ENGINEERING BULLETIN

Horizontal auger slugs, mainly in small grains or upon initial start up.

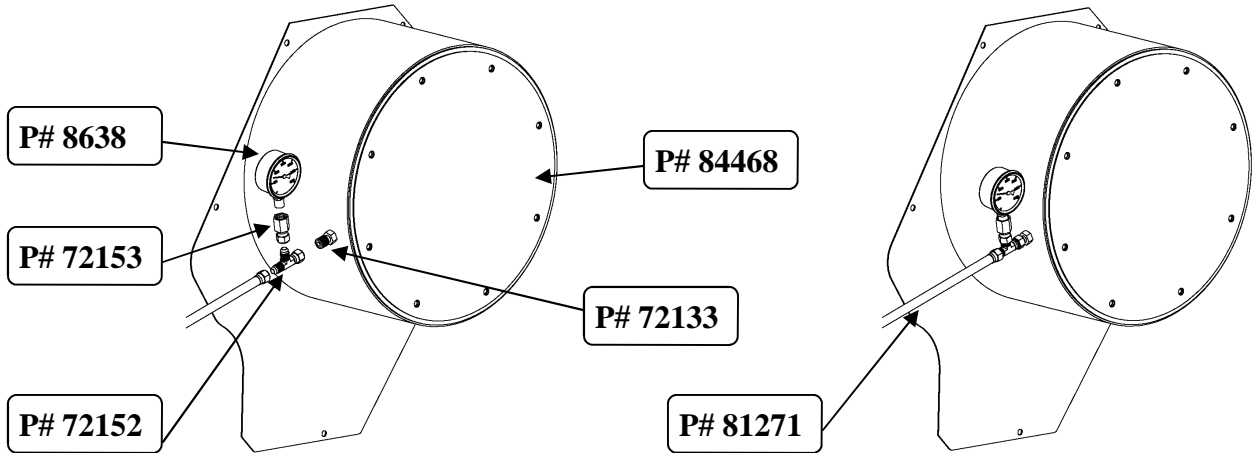
Loosen hydraulic hose **P# 81271**

Connect T-fitting **P# 72152** to bulkhead fitting **P# 72133**. Connect JIC Female adapter **P# 72153**. Connect pressure gauge **P# 8638** to female adapter using Teflon thread tape. Re-connect hydraulic hose **P# 81271**. Tighten all connections.

Clean Horizontal Auger Rotor and Bleed Brake Caliper

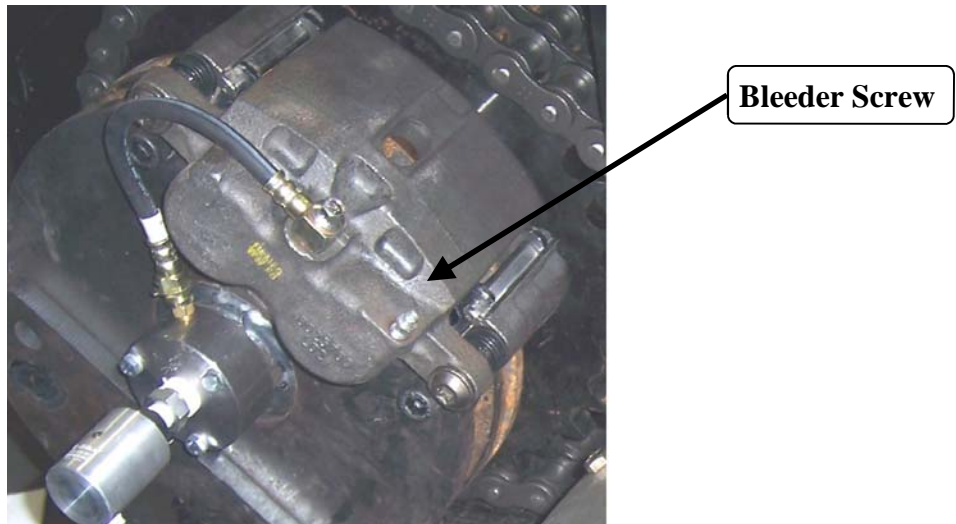
Remove brake clutch cover plate **P# 84468**. Rotate brake caliper so the bleeder screw is at the highest position. Loosen brake caliper bleeder screw to remove any air. Once only fluid escapes, tighten bleeder screw. Use brake cleaner to remove any hydraulic fluid and debris from brake rotor. **Make sure not to spray any brake cleaner on the brake pads.** Replace brake clutch cover plate **P# 84468**.
